City of Biddeford
Planning Board
July 21, 2021 6:00 PM City Hall
Council Chambers, & Zoom:
Jul 21, 2021 06:00 PM Eastern Time (US and Canada)
Topic: Planning Board

5. **UNFINISHED BUSINESS**
6. **NEW BUSINESS**
 - 6.A. 2021.17 - Public Hearing and Preliminary Subdivision/Site Plan Review for a proposed Contract Zone for Adams Point, LP and Southern Maine Affordable Housing at 69 Adam's Street (Tax Map 38, Lot 296) to allow for 39 units of multi-family housing in a 5-storey, 60 foot tall building (plus additional height for utility and elevator structures at a reduced parking provision 0.75 parking spaces per unit.
[2021.17 Board Report - Adams Point Prelim Plan.pdf](#)
[Site Plan Review Application & Supporting Materials_06-14-2021.pdf](#)
[Tansley Transmittal 06-14-2021.pdf](#)
[Adams Point Drawings Site Plan Review 06-14-2021.pdf](#)
[2021.10 HPC 69 Adams St COA.pdf](#)
[2021-06-25_69 Adams Street - Engineering Dept Comments.pdf](#)
[Saucier to Tansley 07-07-21.pdf](#)

Site Plan/Subdivision Preliminary Plan Review

ADAMS POINT HOUSING
69 Adams Street
Biddeford, Maine, 04005

1 EAST DRIVE PROFILE
C-301 SCALE: 1"=30' HORIZ, 1"=3' VERT

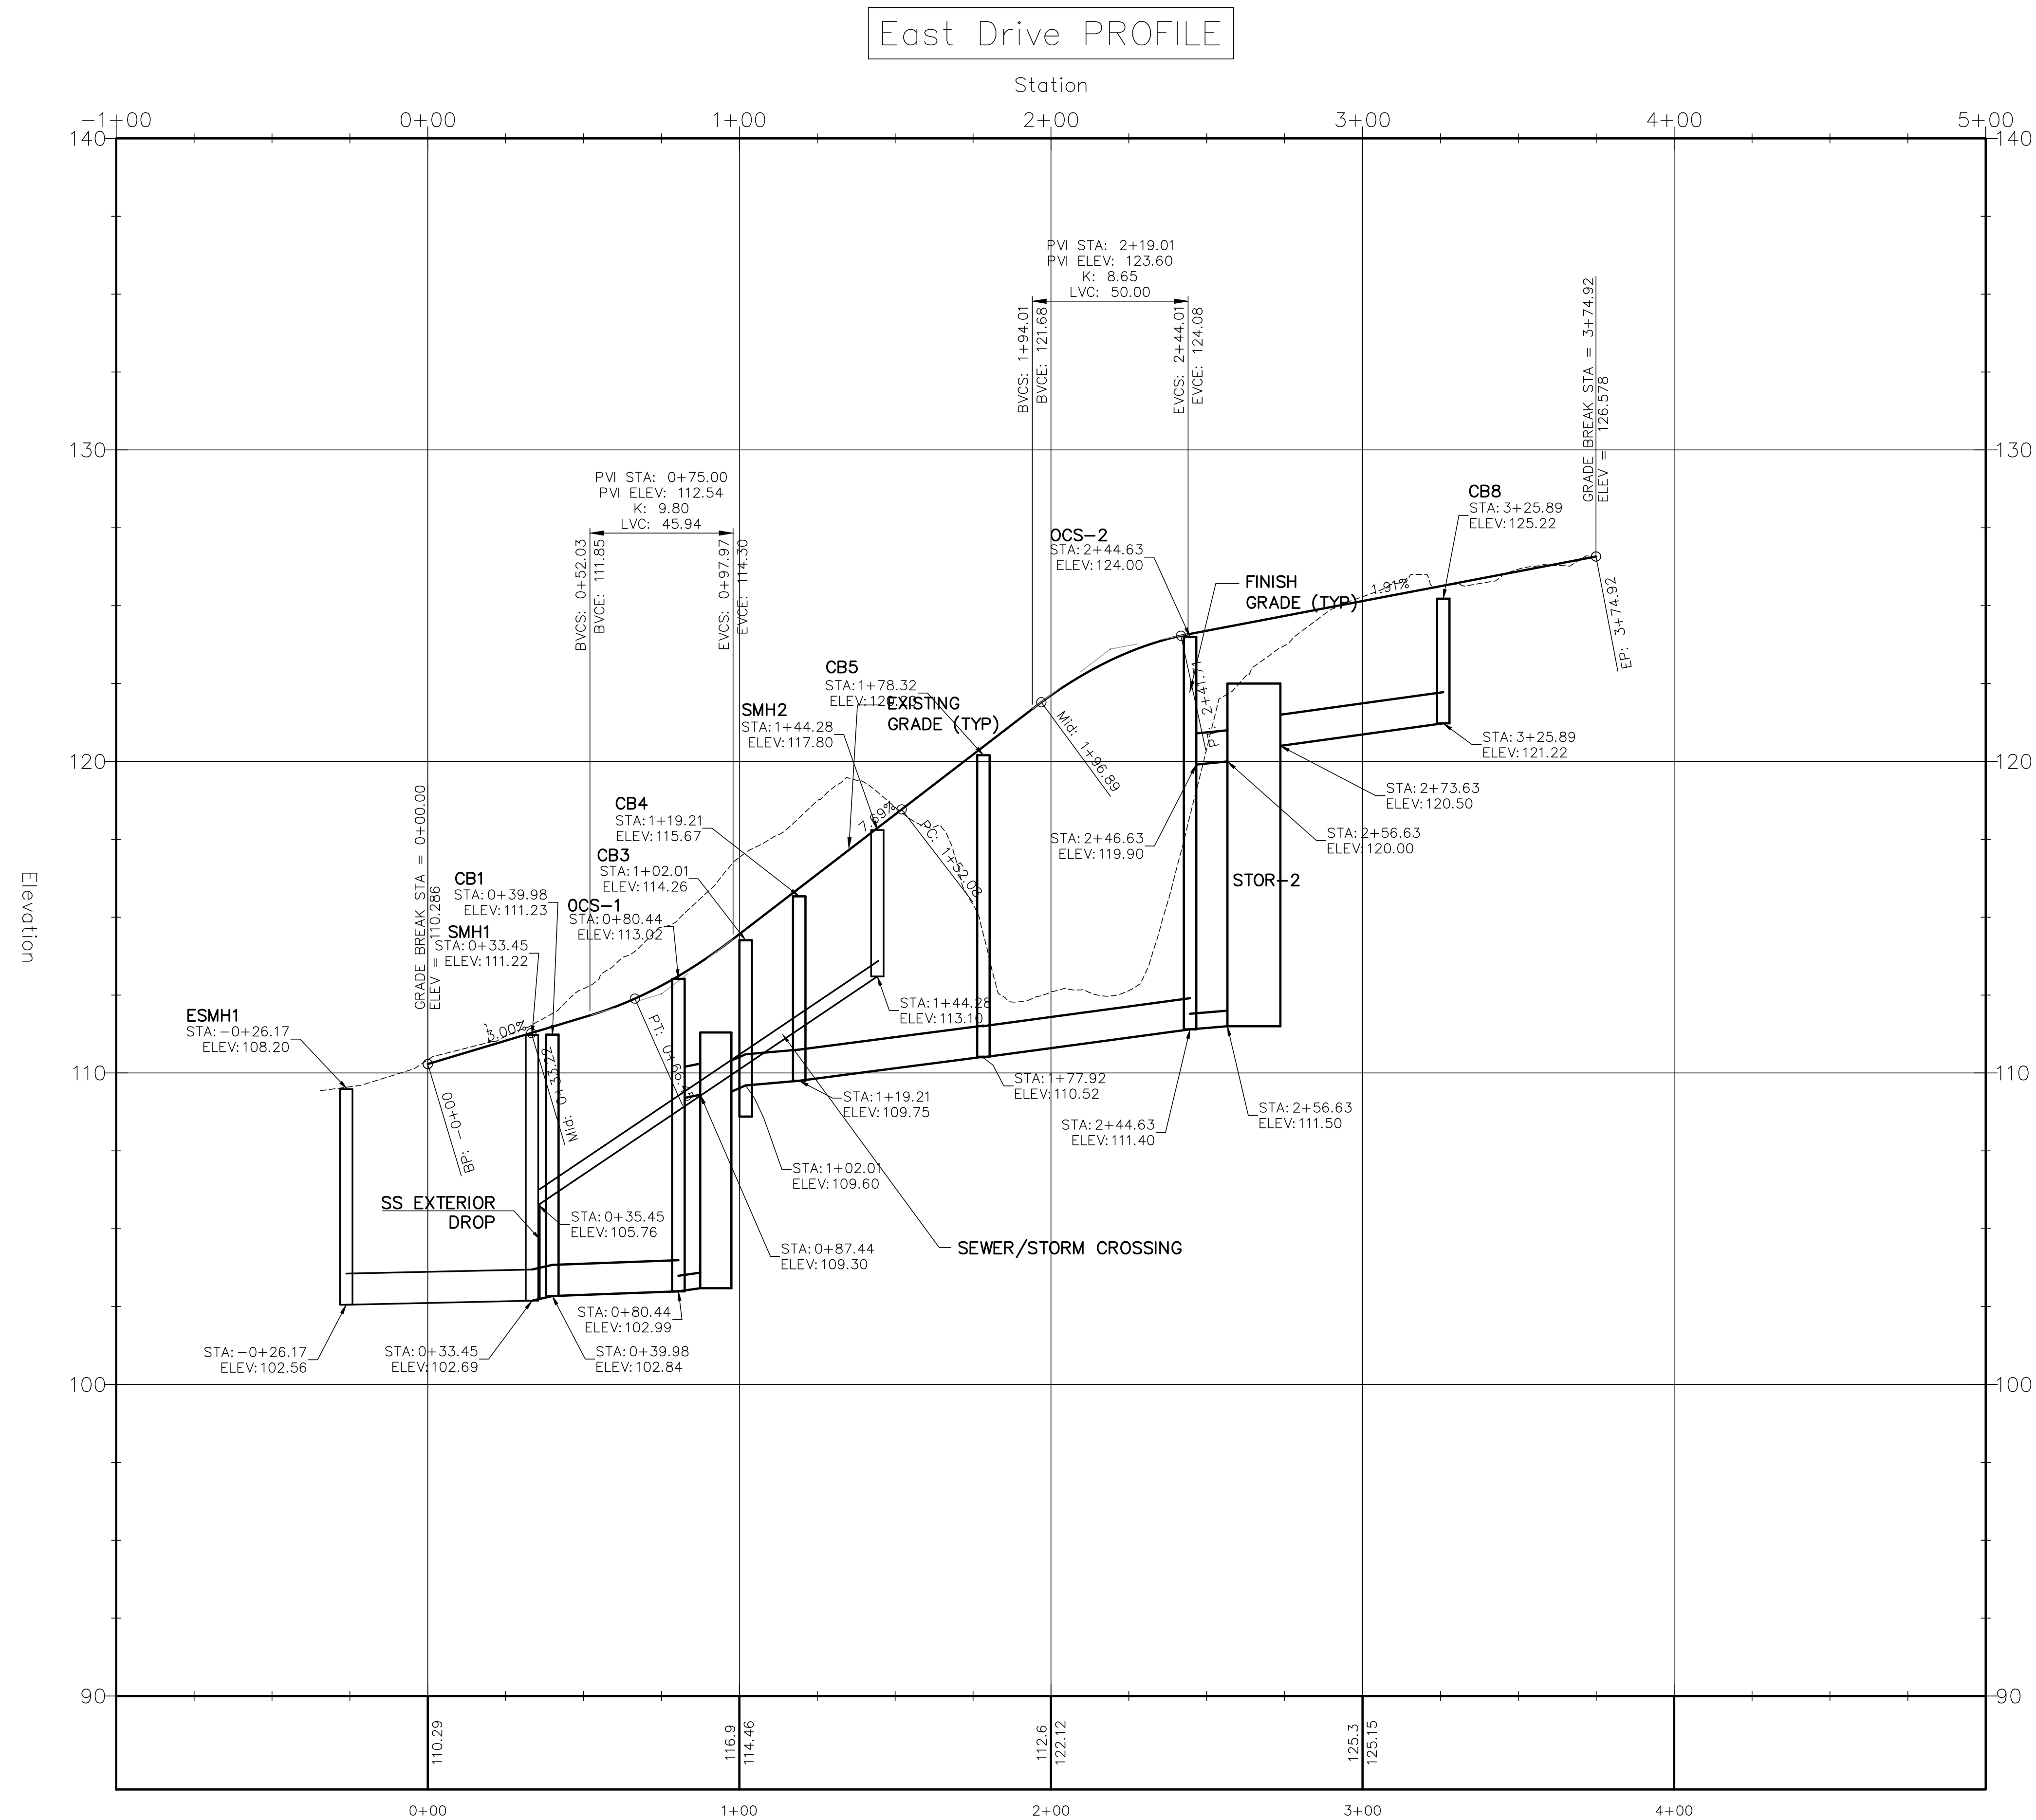
- **Sheet C-301**
 - o STOR-1 not labeled
- **Sheet C-503**
 - o Detail 4 – connection locations for sidewalk underdrain and retaining wall underdrain should be identified

SITE DETAILS - 1

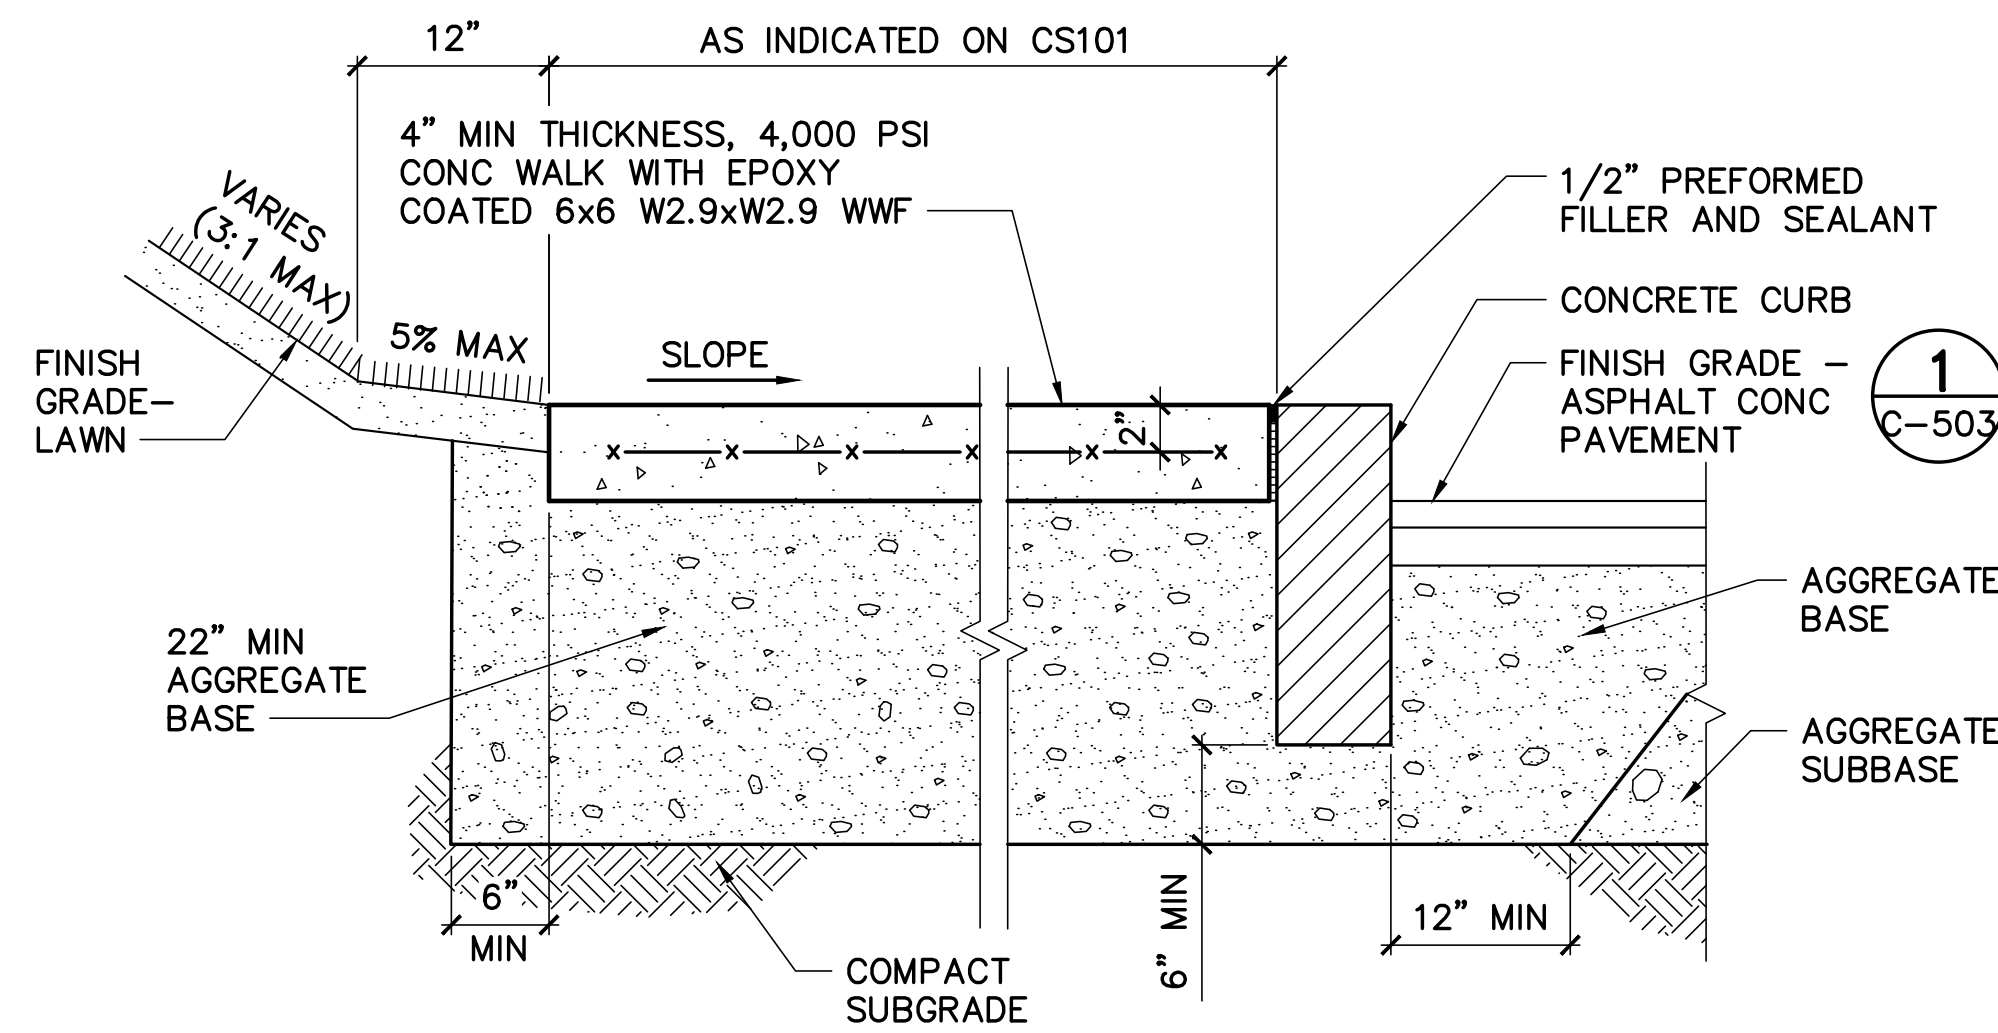
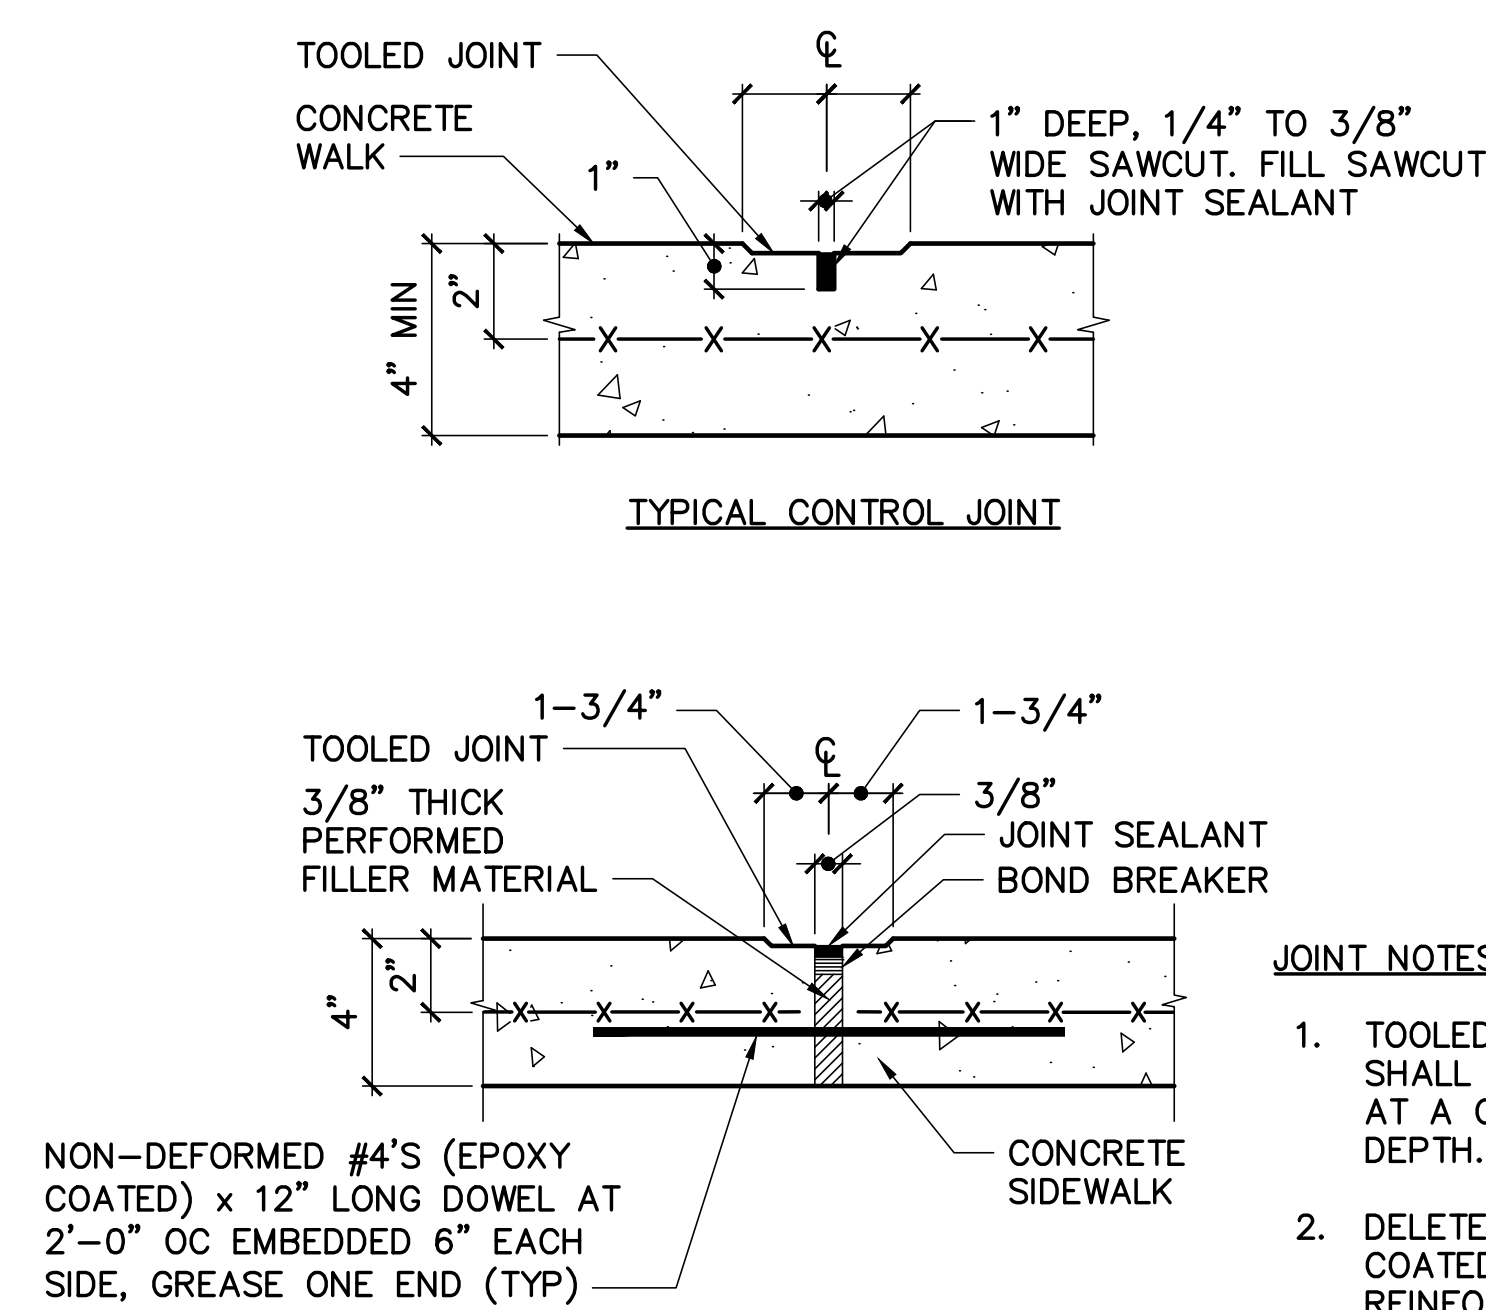
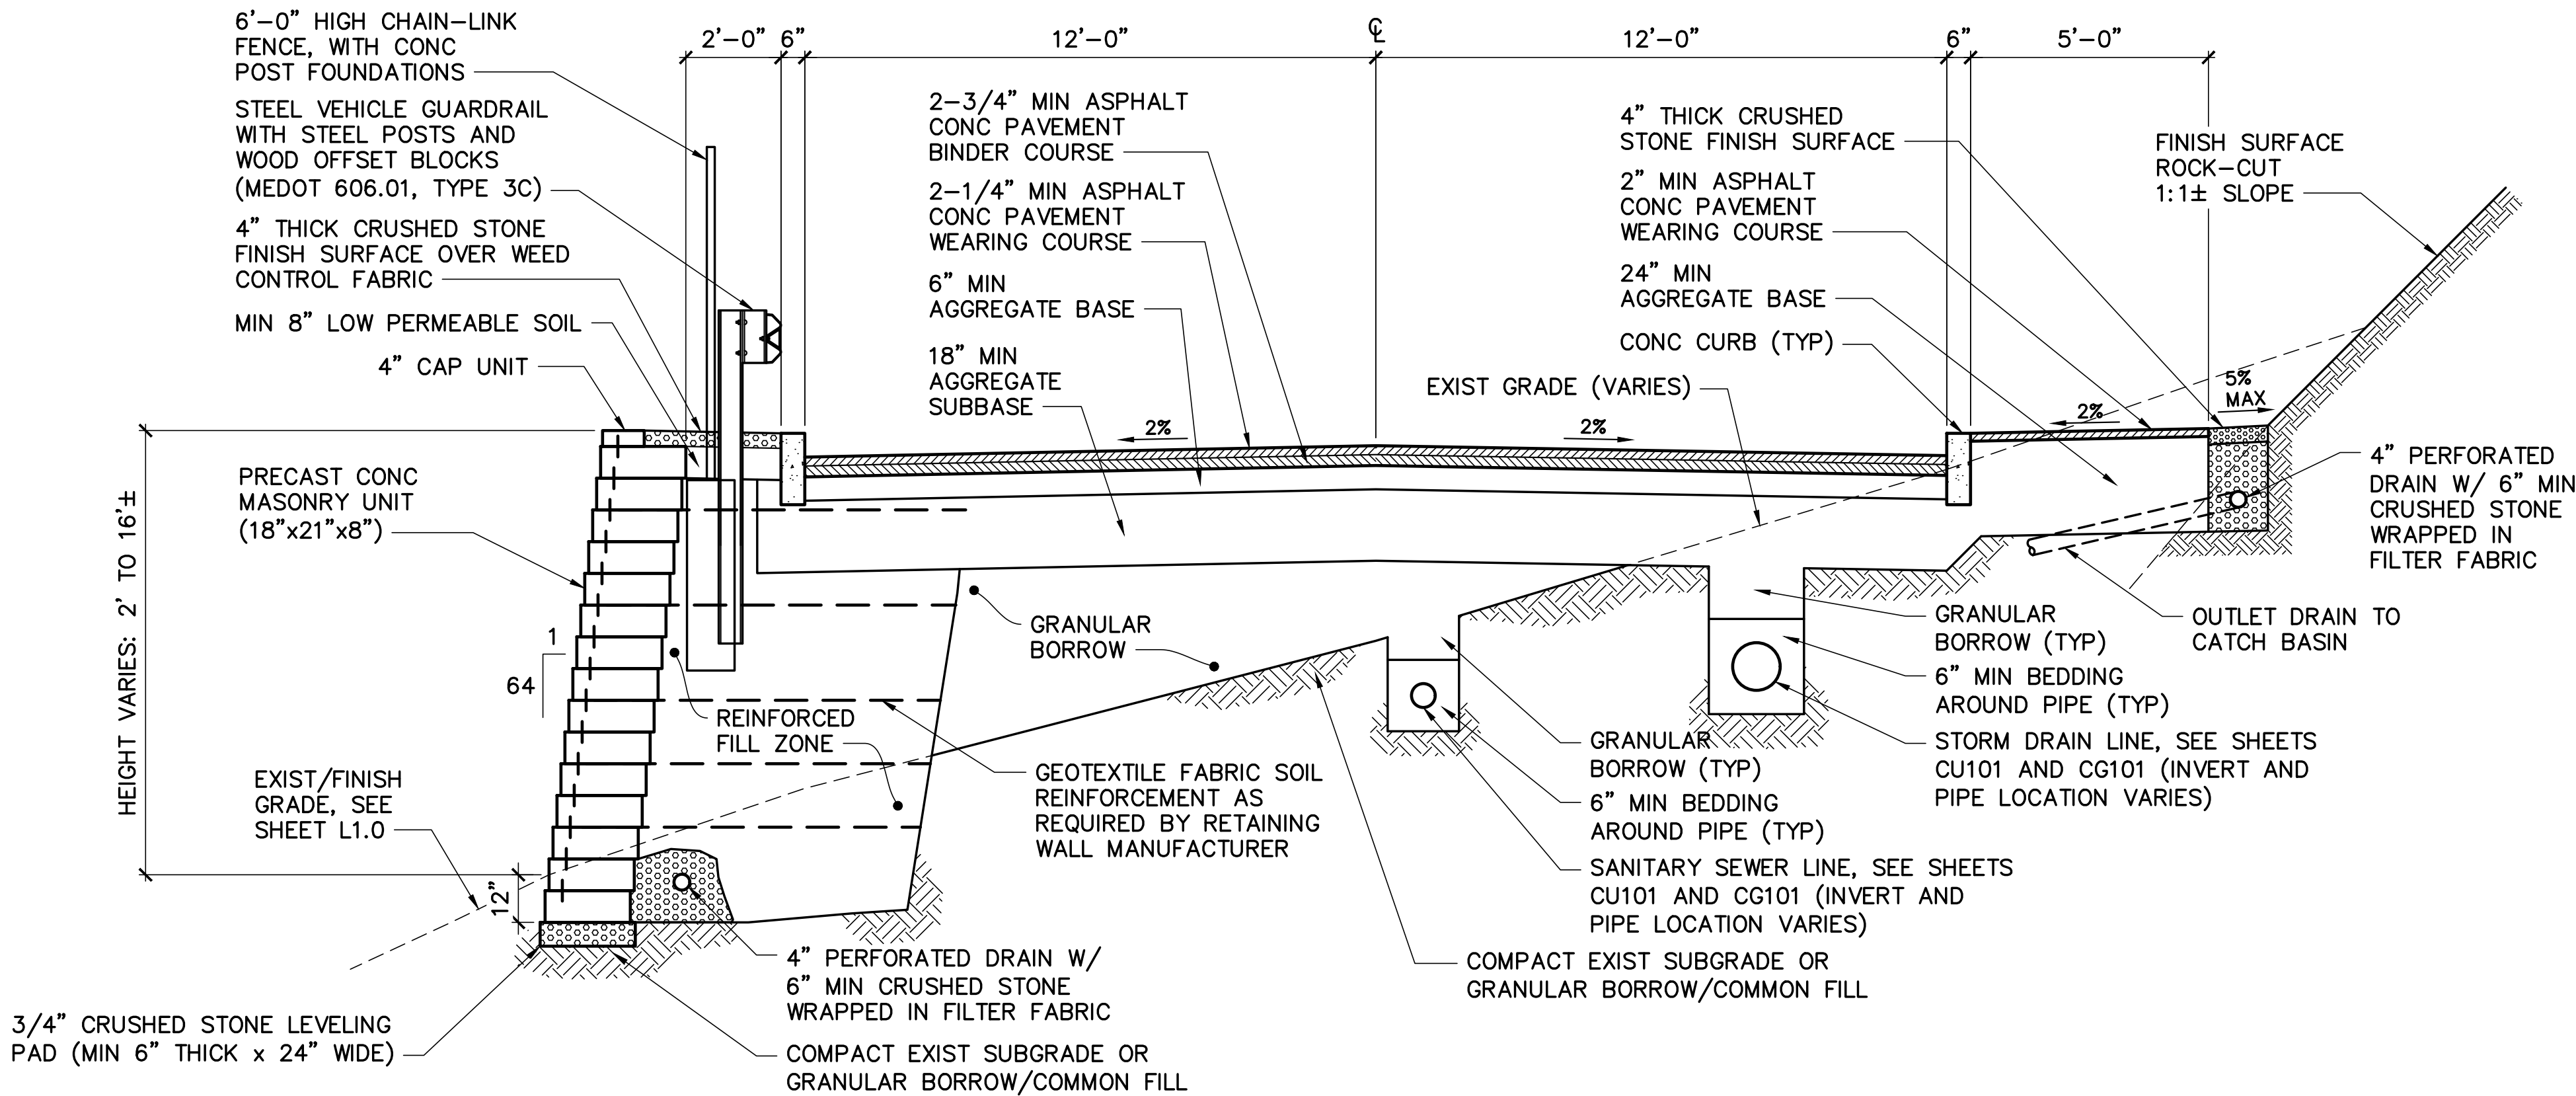
4. Sheet 11 of 19 – Site Details -1
